CONQUER ELECTRONICS CO., LTD. 產品變更通知單 Product Change Notification

PCN 編號: PCN-BLOCK-2018 日期(date): 2020/05/28

客户(Customer)	Anglia Components Ltd.
主 旨(Subject)	Change of dimension of terminals for 5x20mm fuse block
預估生效日期(Estimated effective date)	2020/05/28 Running change

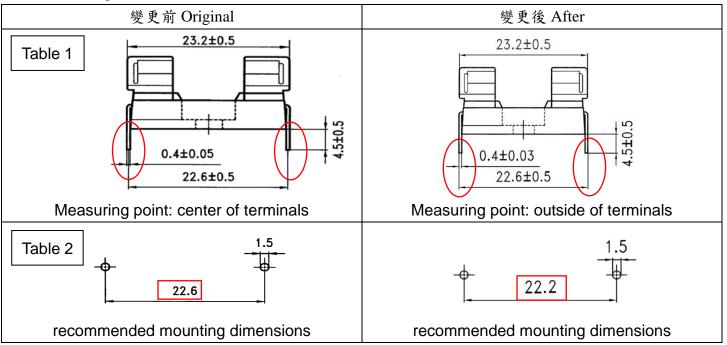
實際交貨產品尺寸不變,工程規格修改以反應實際產品。

端子標示位置調整與建議孔距離調整,如下圖所示。

The engineering specifications are modified to correspond to the delivered products. The dimension of actual delivered product is unchanged.

The measuring position for terminal and the recommended mounting dimensions are changed as following table.
